From: [REDACTED]
To: [REDACTED]
CC: [REDACTED]
Sent: 2/23/2021 6:39:50 PM
Subject: RE: O8W-PM 35217268, 35224712, 35224713 - Bucks Creek 1101 Phase 1,2&3 - Pre-Engineering Meeting

Subject: O8W-PM 35217268, 35224712, 35224713 - Bucks Creek 1101 Phase 1,2&3 - Pre-Engineering Meeting

PM 35217268 (Phase 1)

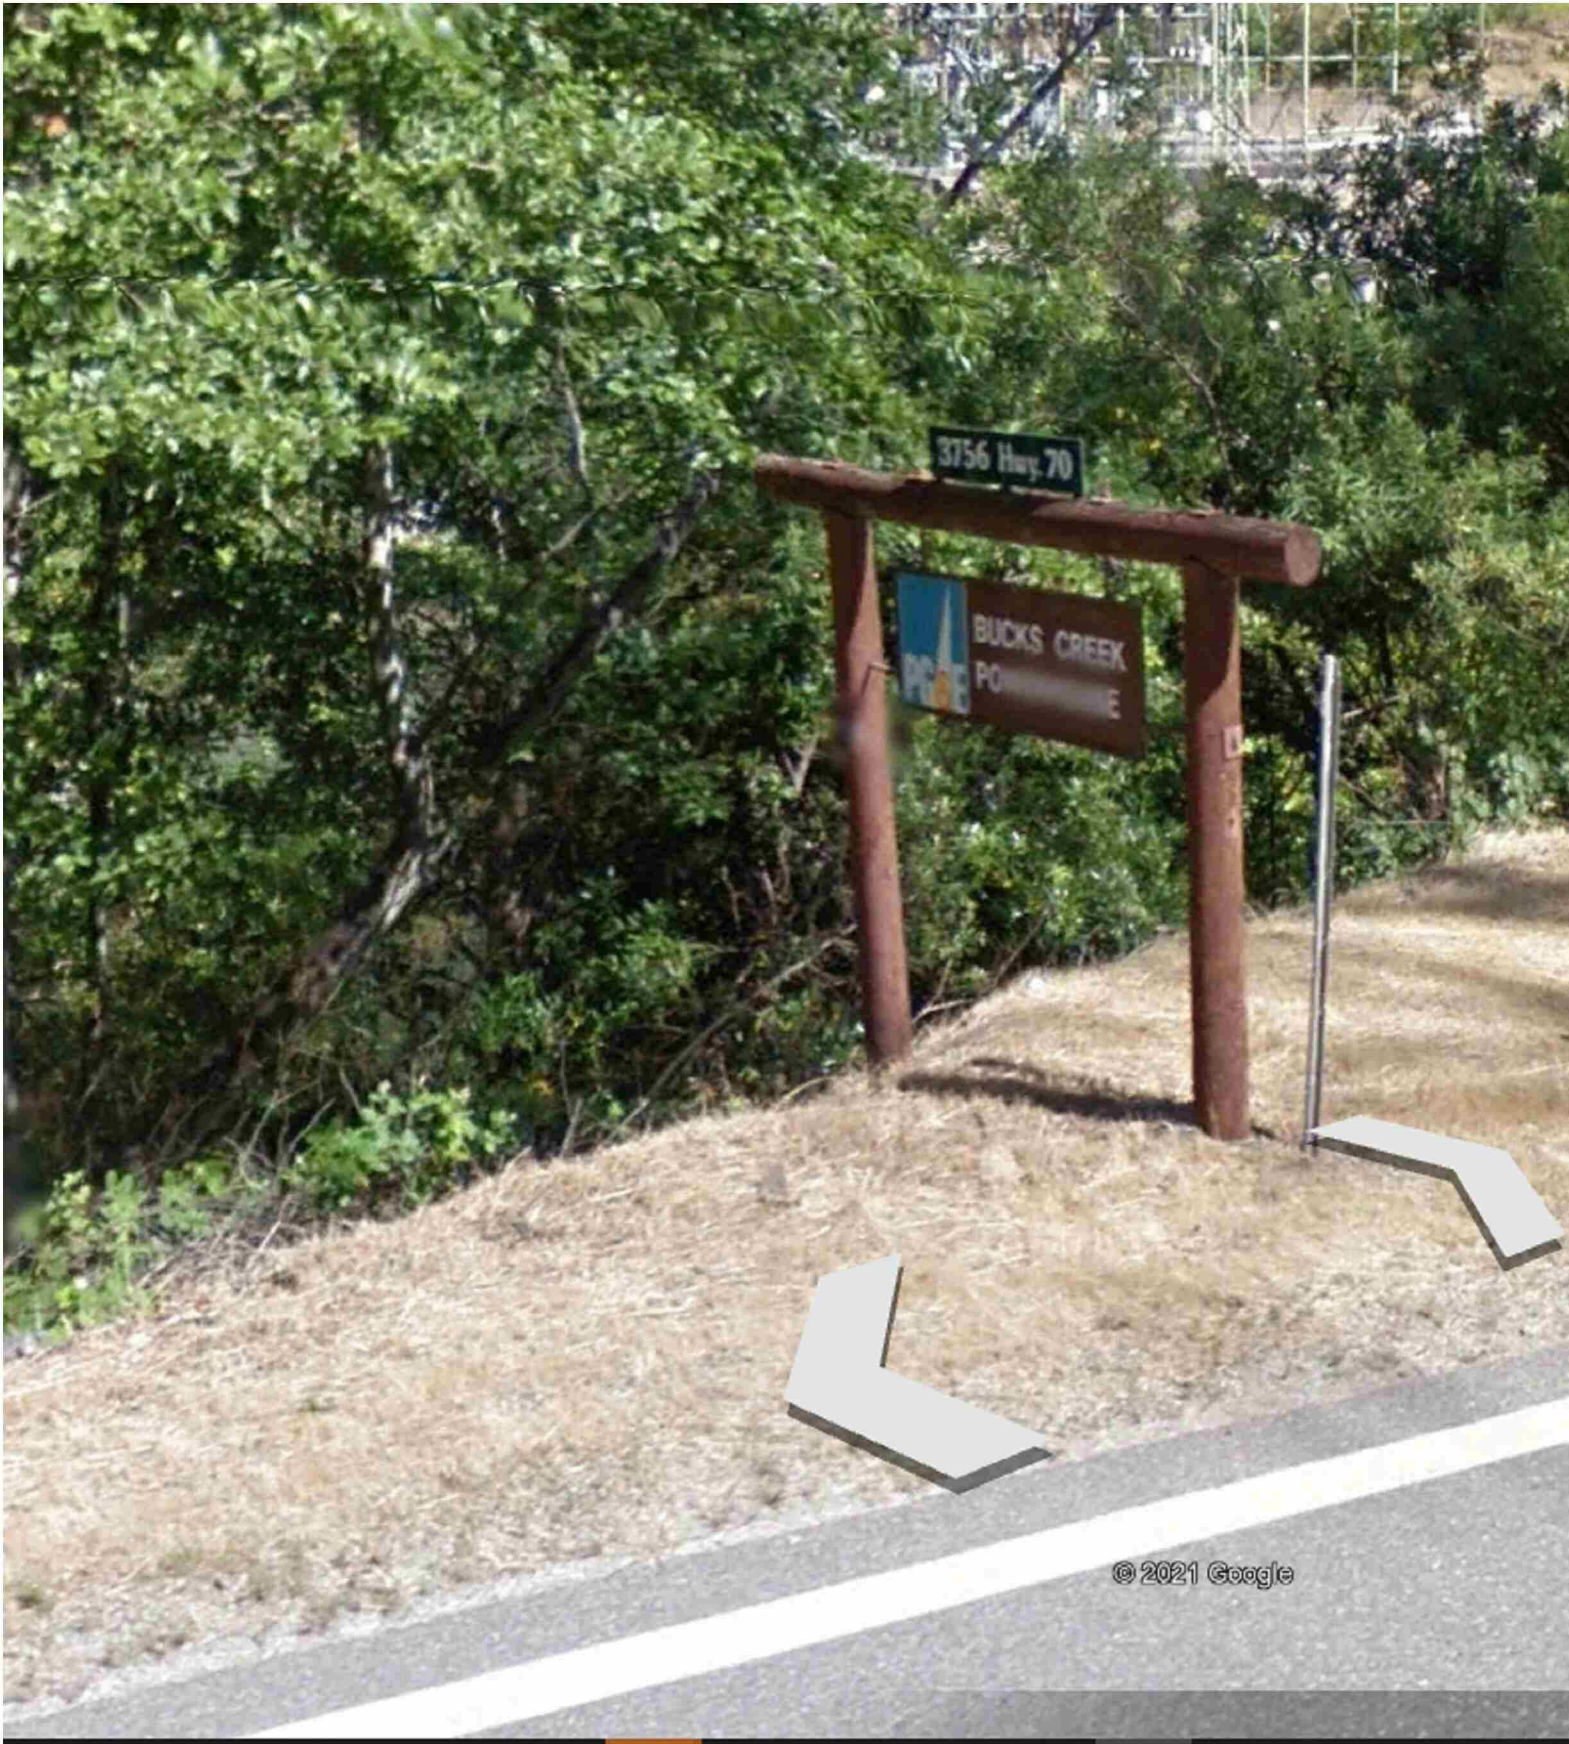
Attached are the 'base-map' limits in a kmz. file. As you will see, we need our base-map to go about ~100' into the tunnel at the south end (see pedestal in picture below....please begin about ~50 beyond this point which is about ~100' beyond the Cresta Dam).
